UNITED STATES OF AMERICA  
NUCLEAR REGULATORY COMMISSION

In the Matter of	)	Docket Nos. 50-329 OM & OL
	)	50-330 OM & OL
CONSUMERS POWER COMPANY	)	
(Midland Plant Units 1 and 2)	)

NRC STAFF TESTIMONY OF DARL HOOD, JOSEPH KANE,  
FRANK RINALDI AND EUGENE GALLAGHER ON STAMIRIS CONTENTION 2

Figure 37-1

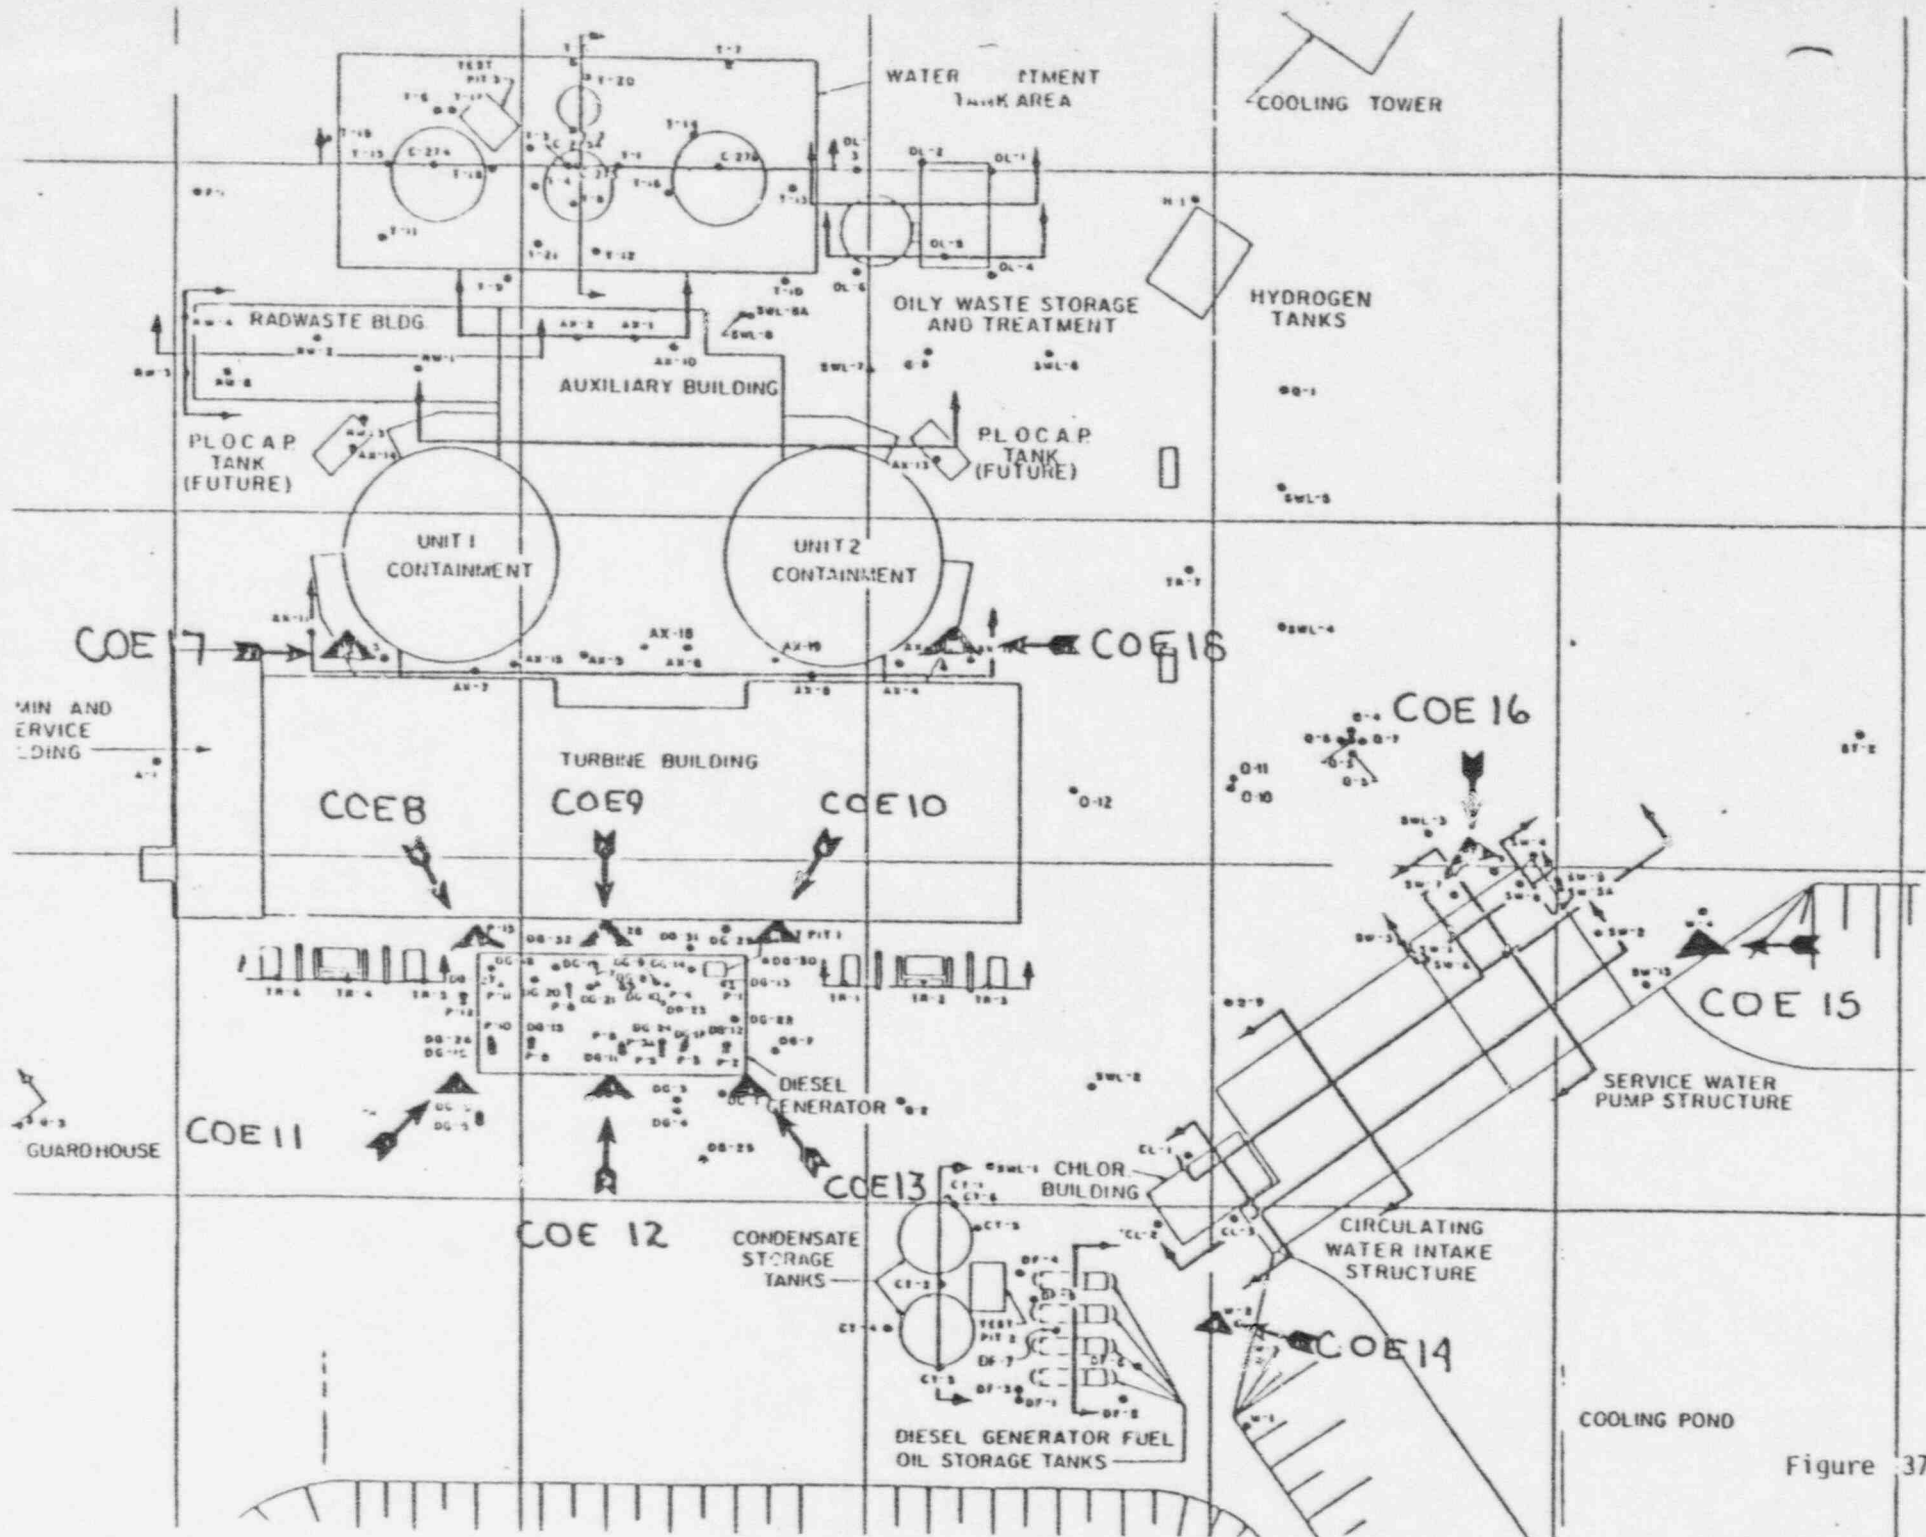
36. We have reviewed your response to Request 24 and find that information from additional boring logs is needed.

Provide the boring logs for the following explorations:

The logs should include date and method of drilling, the type and location of samples attempted. Also provide the locations, boring logs and available test data of any exploration completed in 1979 and 1980 which has not yet been submitted.
